Permit Number: 040791

# City of Portland, Maine - Building or Use Permit Application

<b>Location of Construction:</b> 165 St John St	<b>Owner Name:</b> Khamis Rose J	<b>Owner Address:</b> 165 St John St	<b>Phone:</b> 207-780-1341
<b>Business Name:</b>	<b>Contractor Name:</b> Maplewood Development	<b>Contractor Address:</b> Box 130 Eliot	<b>Phone:</b> (207) 252-0162
<b>Lessee/Buyer's Name</b>	<b>Phone:</b>	<b>Permit Type:</b> Additions - Duplex

<b>Proposed Use:</b> two family	<b>Proposed Project Description:</b> 22' x 30
------------------------------------	--

26-0 \* 15-0  
 2nd Floor

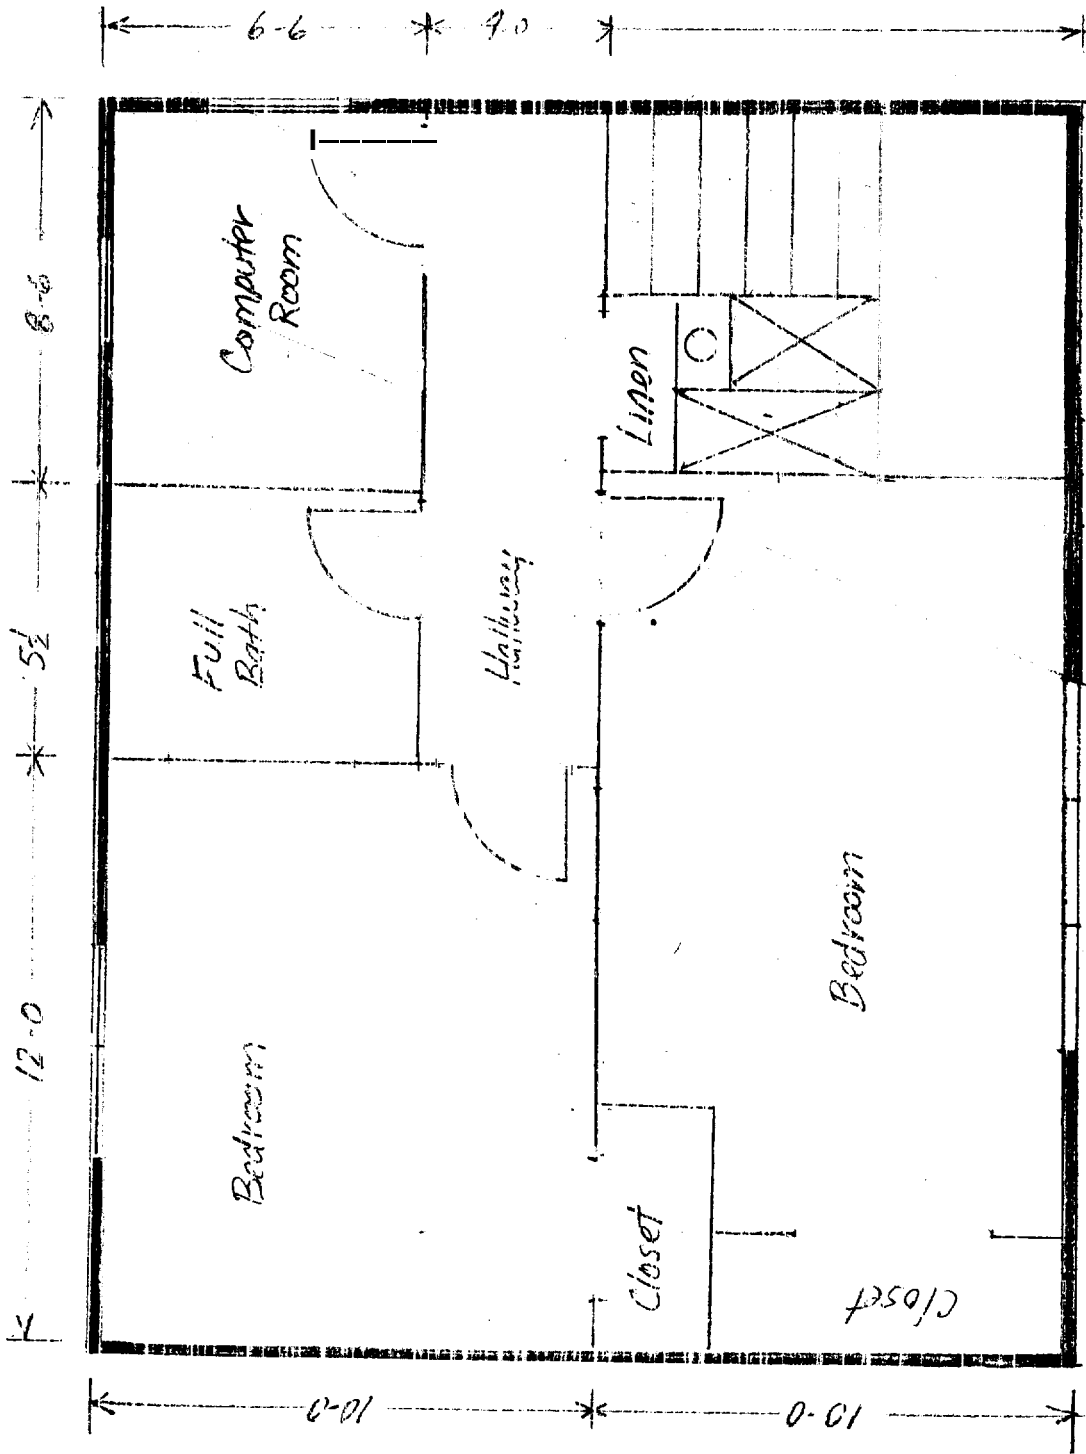
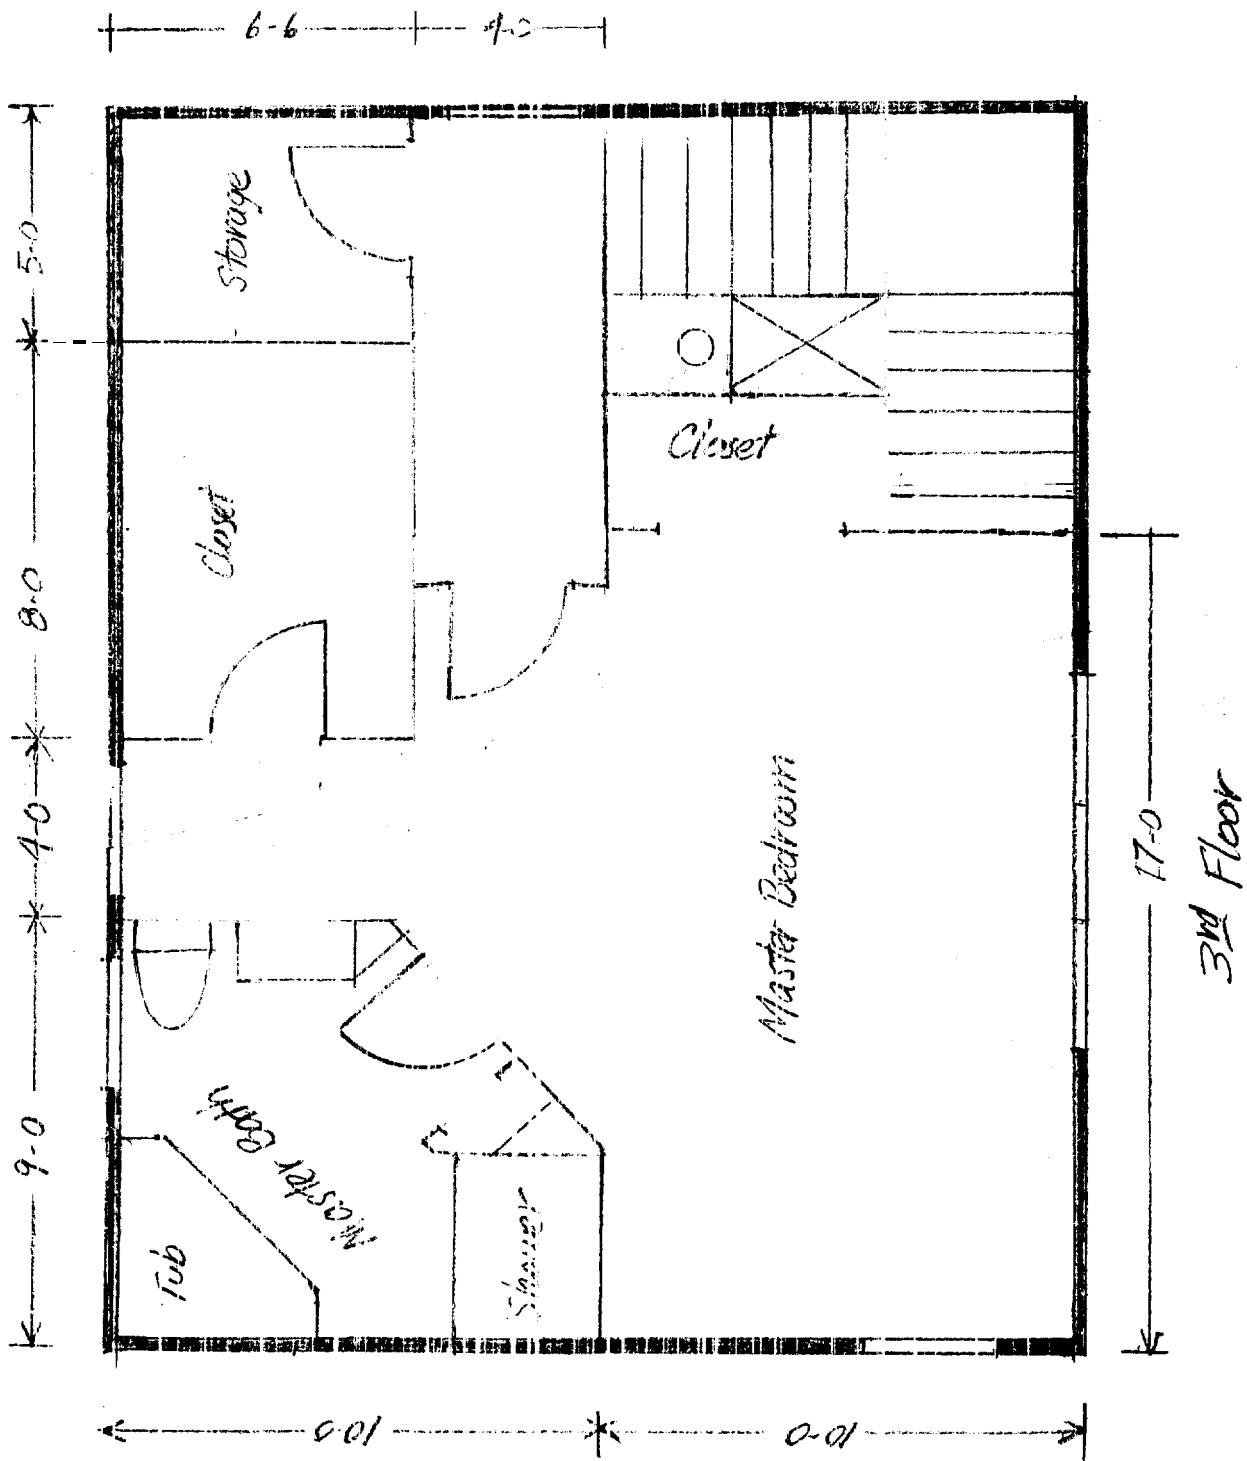
9/28/04-tmm: rec'd plot plan and changes to floor plans - proposed plan meets lot coverage but does NOT meet side setbacks. - left message w/builder.

10/1/04-tmm: rec'd plans 09/27/04 - still need to know how exterior stairs will be framed and header over 6' opening carrying 2 floors above. Zoning issues resolved. Spoke w/builder regarding this.

ADDRESS: 165 ST. JOHN STREET  
PORTLAND, MAINE

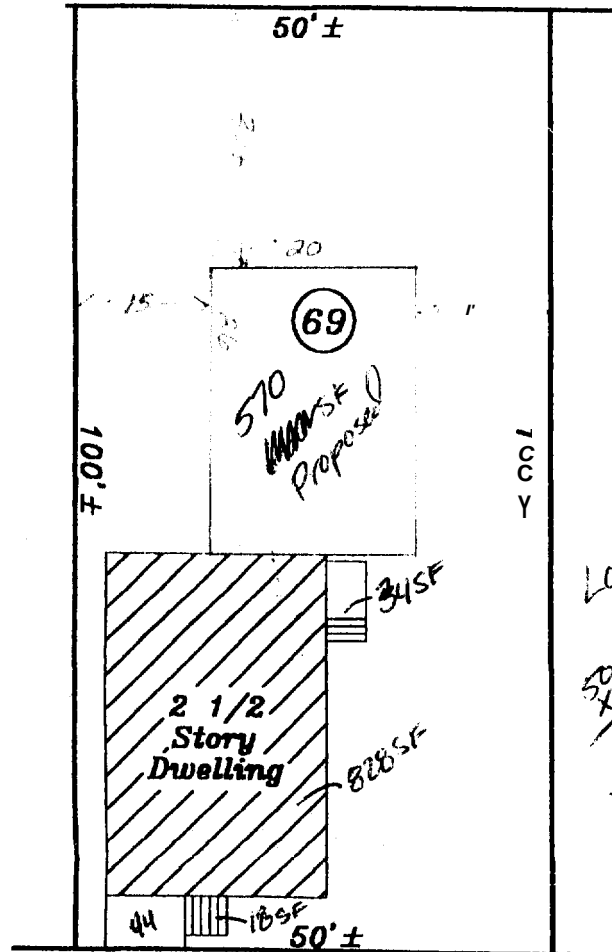
*R-4  
Sides - 16'  
Rear - 25'*

*OK - Under 14-433  
Can reduce  
to 5'-6"*

*Lot. cov  
30% =*

*5000  
x .30  
= 1500  
- 828  
= 672  
- 34  
= 638  
- 44  
= 594  
- 18  
= 576 SF  
LCFT.  
- 570 SF proposed  
OK*

ADDRESS: 165 ST. JOHN STREET INSPECTION DATE: DECEMBER 9, 2002  
PORTLAND, MAINE SCALE: 1"=20'

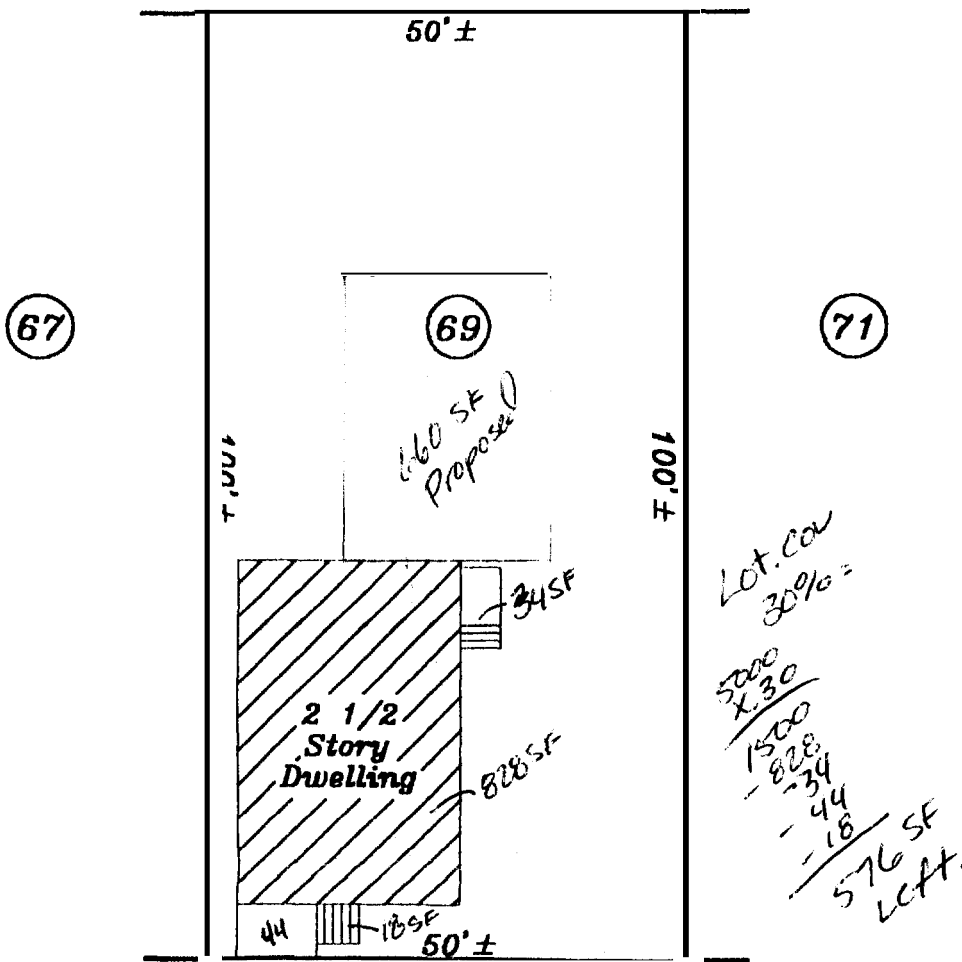
*R-4  
Front - Rear - 25'  
Side - 1 story 10'  
2 story 14'  
Lot cov. 30%*
